APPLICATION FOR PERMIT TO DRILL		1. WELL NAME and NUMBER NBU 689-30E
2. TYPE OF WORK DRILL NEW WELL <input checked="" type="checkbox"/> REENTER P&A WELL <input type="checkbox"/> DEEPEN WELL <input type="checkbox"/>		3. FIELD OR WILDCAT NATURAL BUTTES

NAME Kaylene Gardner	TITLE Regulatory Administrator	PHONE 435 781-9111
SIGNATURE	DATE 05/21/2009	EMAIL kaylene_gardner@eogresources.com
API NUMBER ASSIGNED 43047504370000	APPROVAL  Permit Manager

Division of Oil, Gas and Mining
OPERATOR CHANGE WORKSHEET

LOCATION LAYOUT FOR
NBU #689-30E
SECTION 30, T10S, R21E, S.L.B.&M.
853' FNL 615' FEL

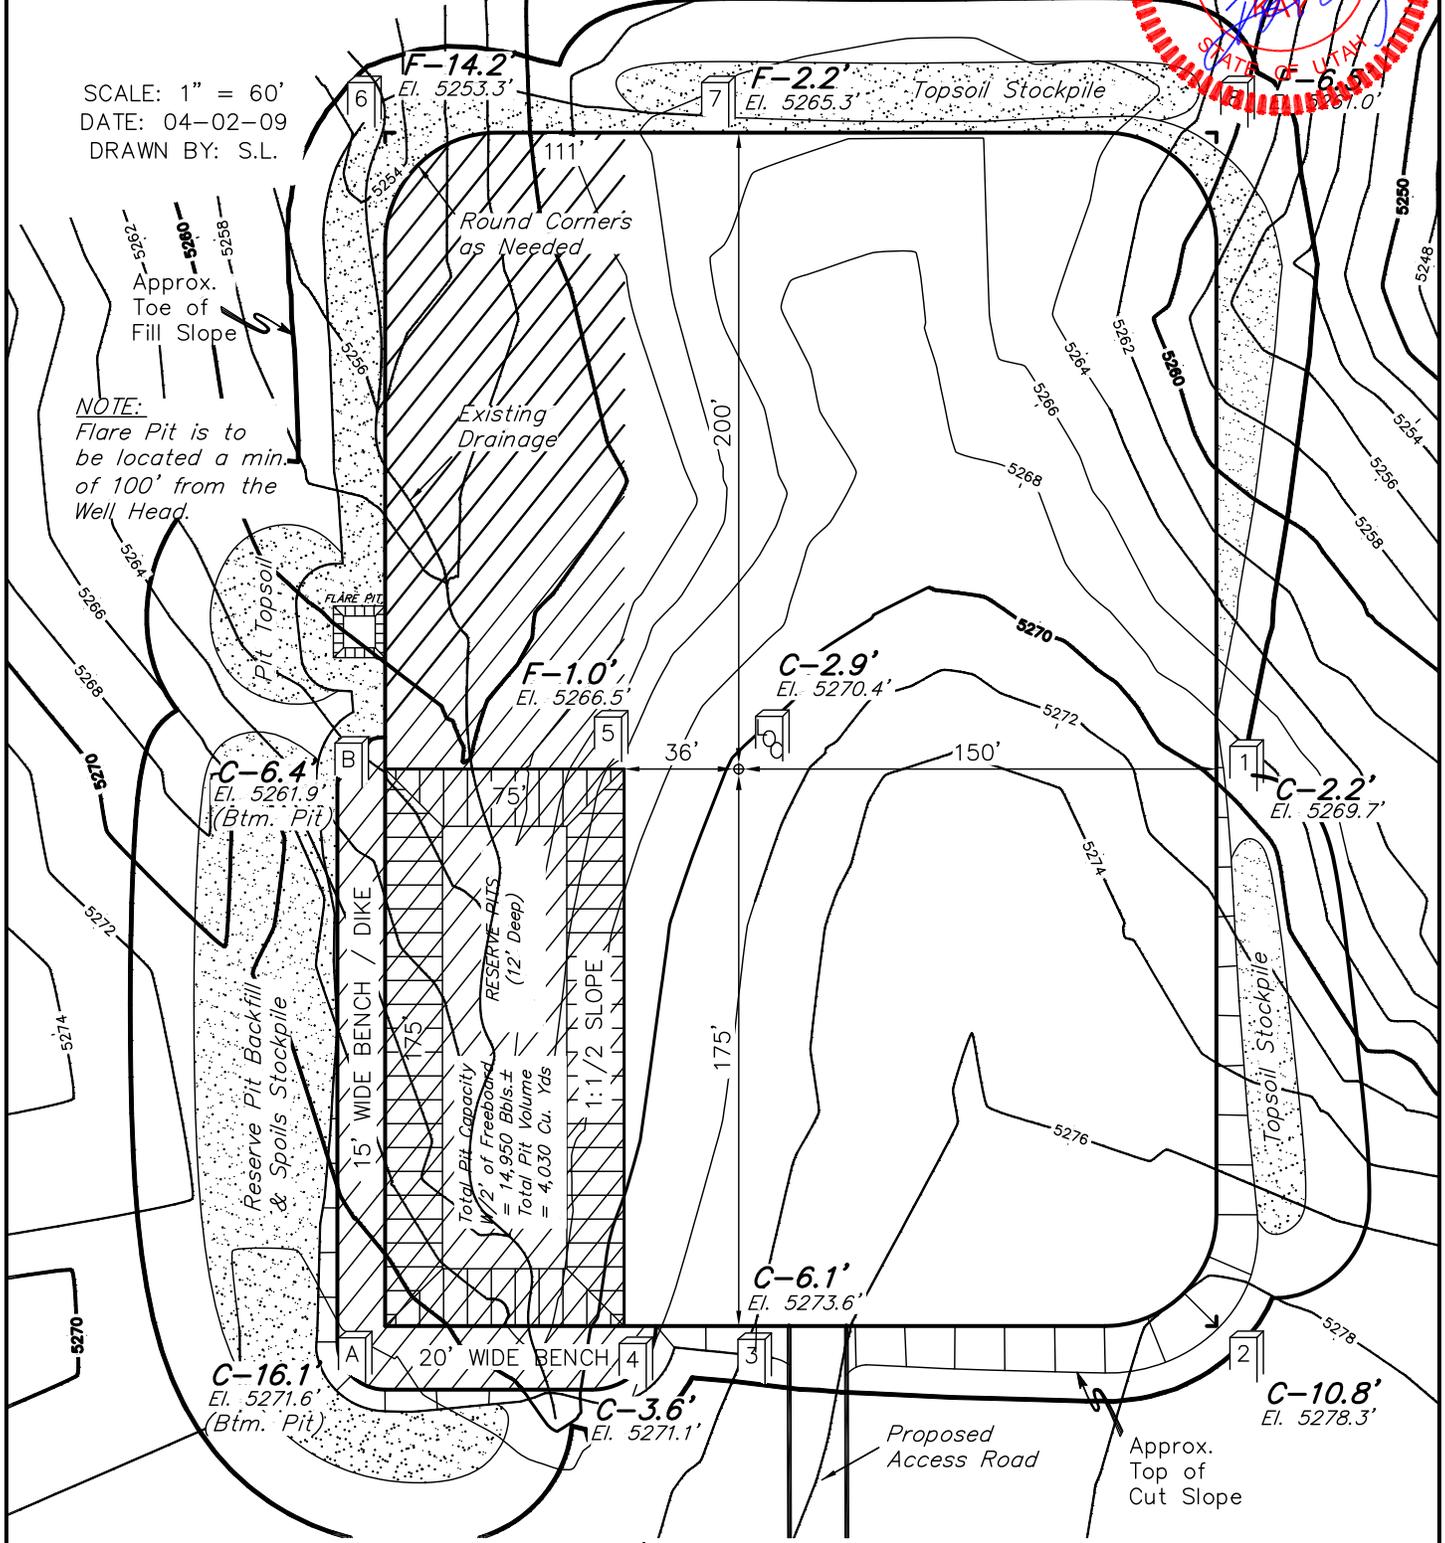
Kayleen Gardner stated that a closed loop mud circulation system would be used rather than construct a reserve pit as shown in the Location Layout plan.
